To: Improved SCSI Protocol Ad-Hoc Group
From: Mike Kosco (MKosco@corp.adaptec.com)
Subject: SCSI LFP - Quick Arbitrate & Select Proposal
Date: Wednesday, September 03, 1997

Figure 1 - QAS Protocol

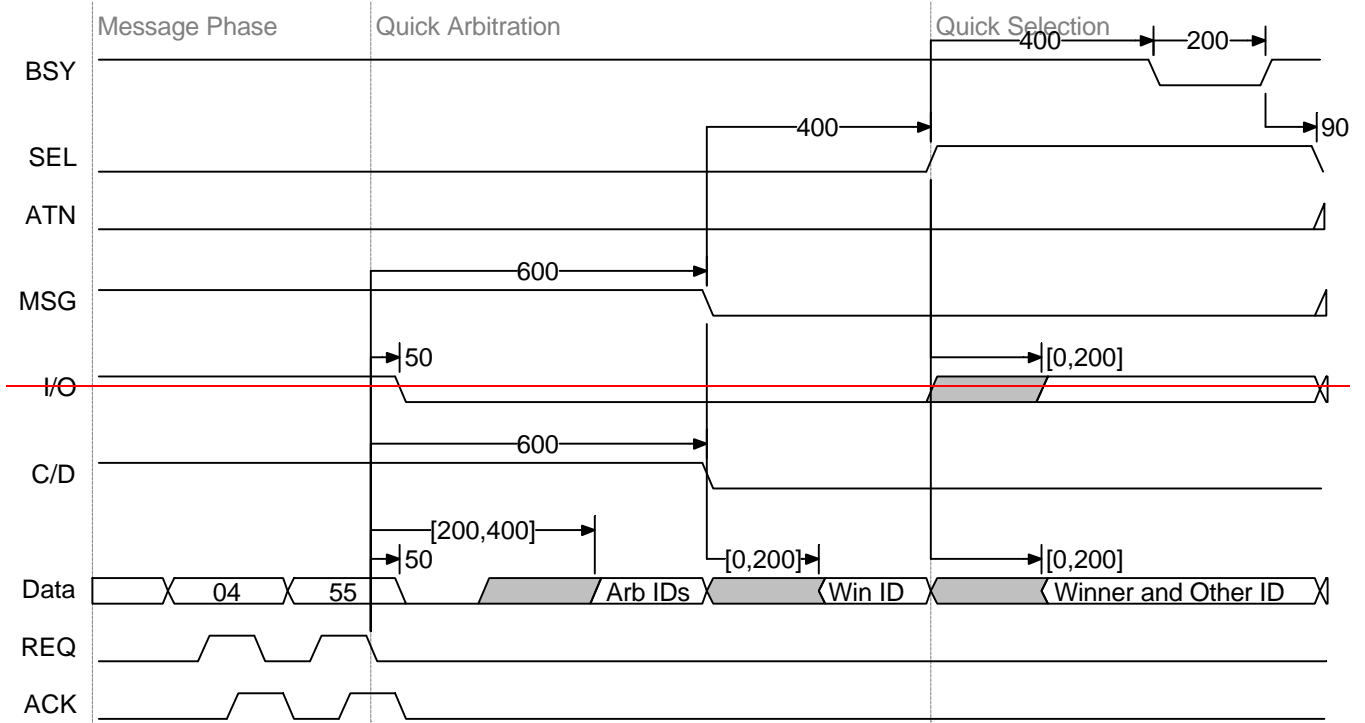
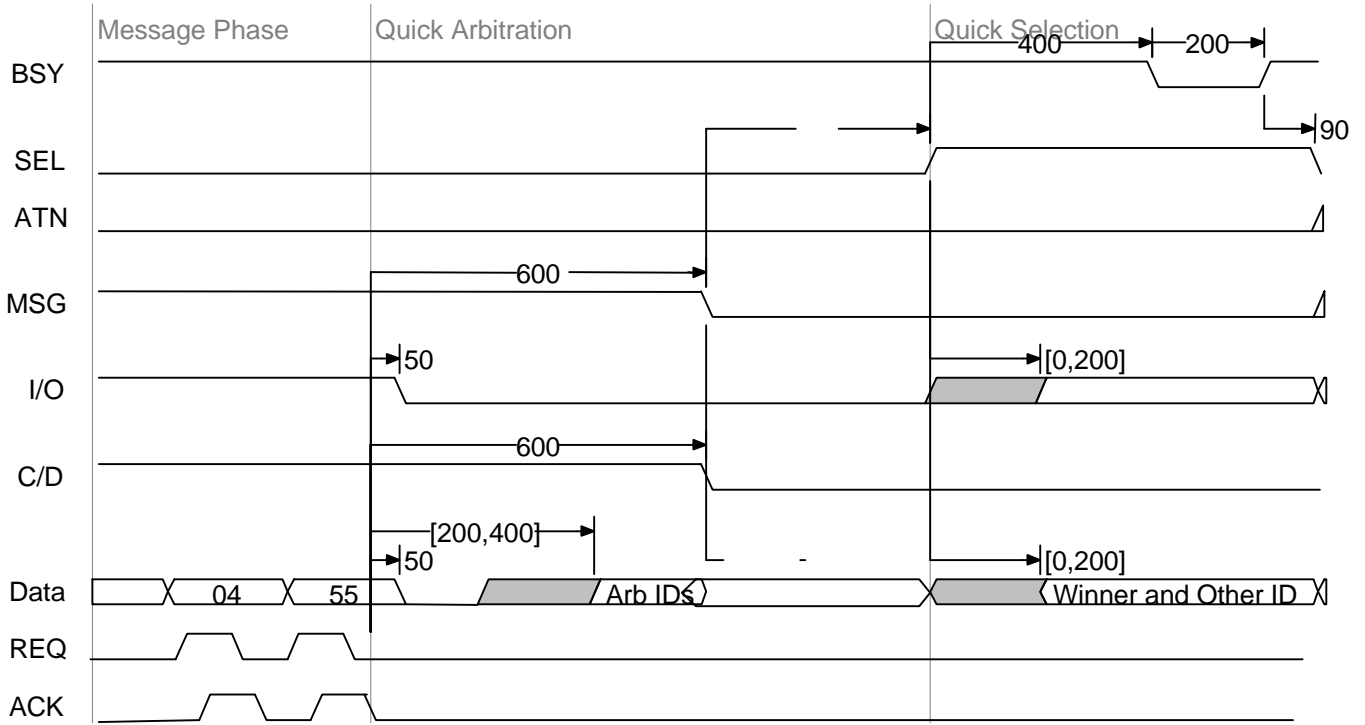
The current QAS Target, after sending the QAS message, negates MSG ~~and drives the winning devices' ID onto the bus.~~

When MSG is detected negated, the participating QAS devices remove their IDs from the bus, ~~while the current QAS Target holds the winner ID on the bus with the winner determined by the SPI-2 fairness algorithm.~~

After removing their IDs, the QAS participants sample the bus to see if their ID is still asserted on the bus to determine if they have won. If so, SEL is asserted by the winner along with it's Own ID and the ID to which it wishes to (re-)select. After SEL is detected asserted, the previous Target negates BSY.
